Arkansas Regional Haze Phase II SIP Proposal

**Arkansas Department of
Environmental Quality
December 1, 2017**

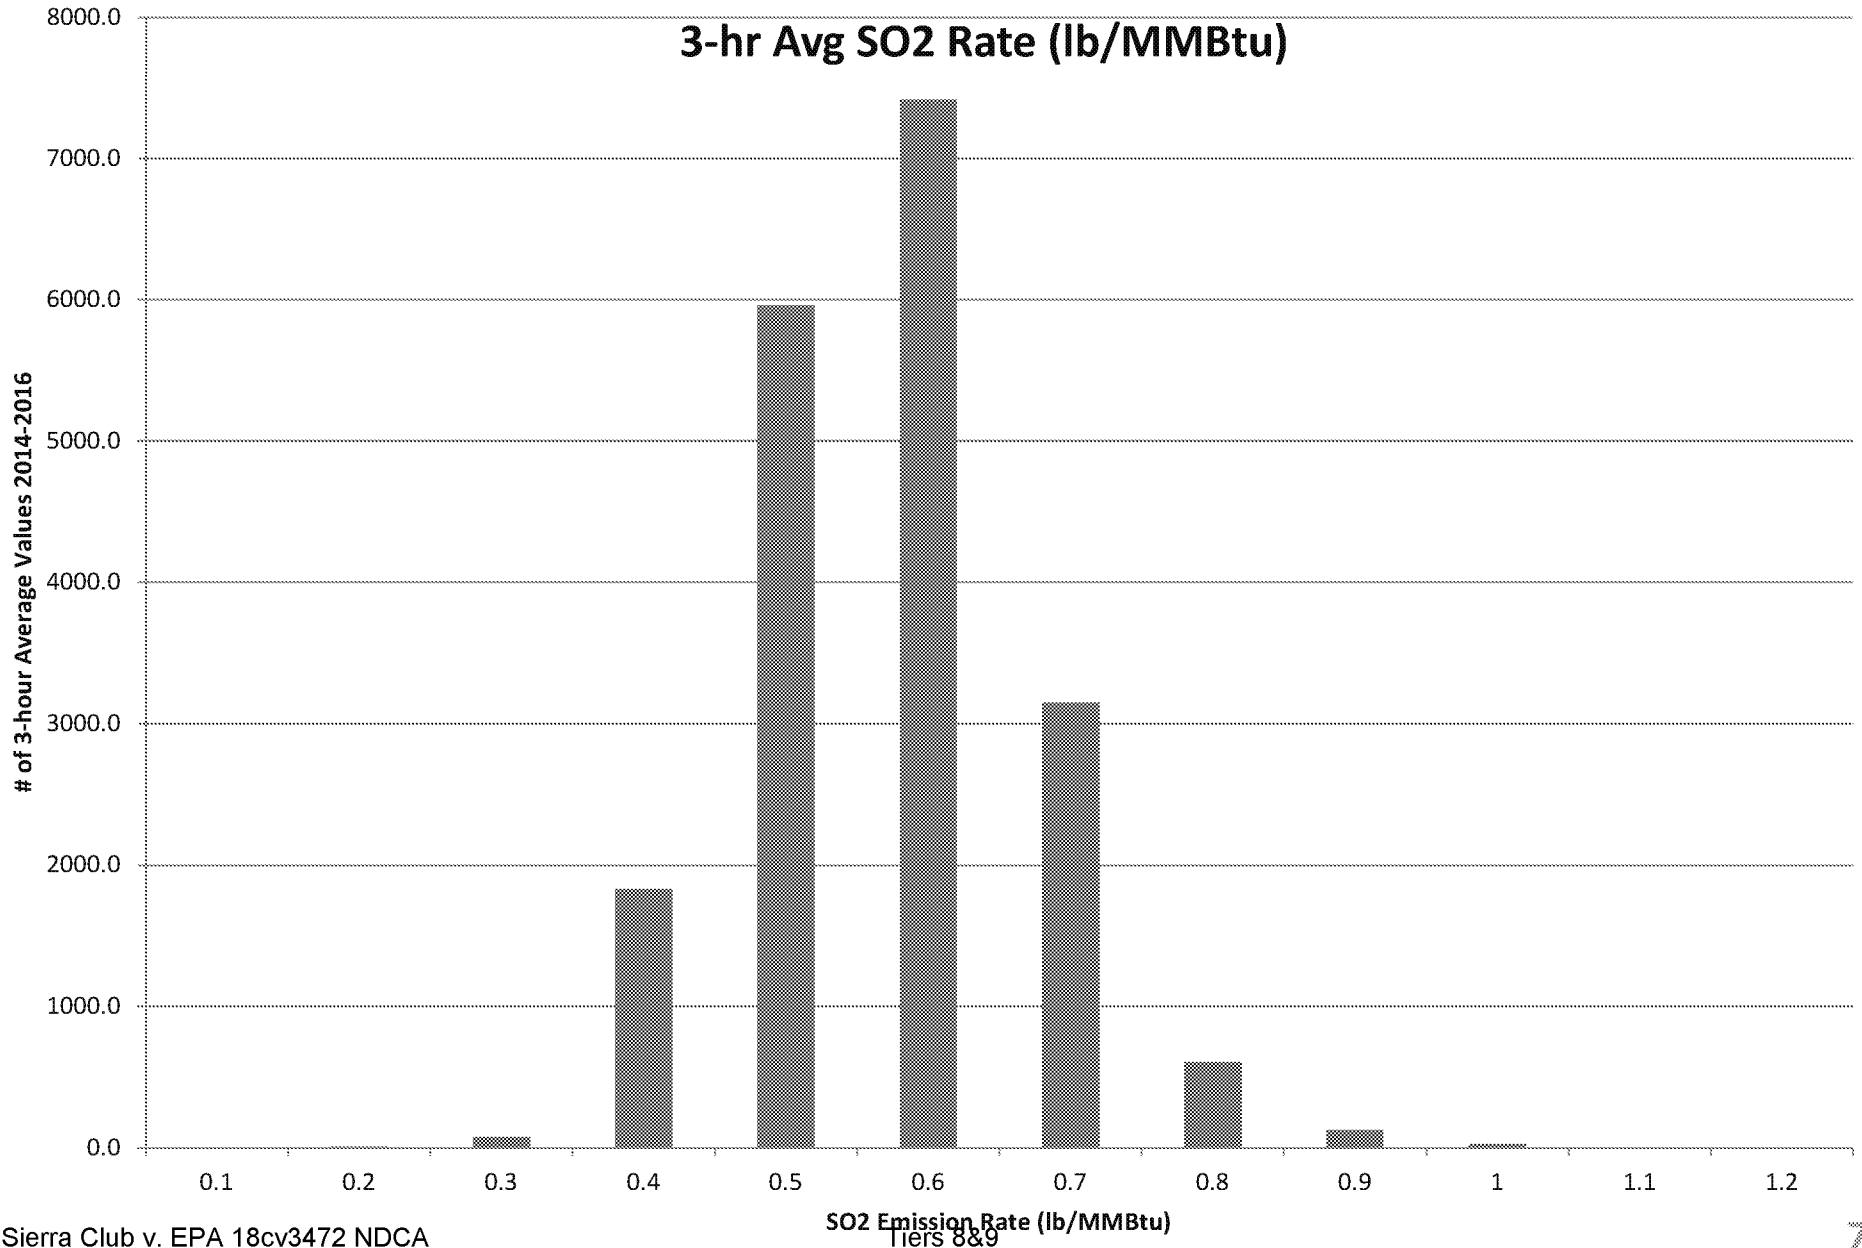
- Proposed SIP compares 30-day average actual SO₂ emission rates to existing 3-hour average permit limits
 - Limits:
 - 1.2 lb/MMBtu (White Bluff)
 - 0.93 lb/MMBtu (Independence)
 - Due to natural variability in coal sulfur content, in order to ensure compliance with applicable short-term (3-hour) limits, Entergy must necessarily achieve long-term (e.g. 30-day) average emission rates well below the applicable short-term limit
 - Proposed SIP draws improper conclusions from this comparison of data with significantly differing averaging times
 - Suggests that plant is currently utilizing low-sulfur coal as an existing control, when actual 3-hour average data indicates maximum emission rates approaching limit

- Example: White Bluff Unit 1
- Data for 2014-2016
- Limit = 1.2 lb SO₂/MMBtu
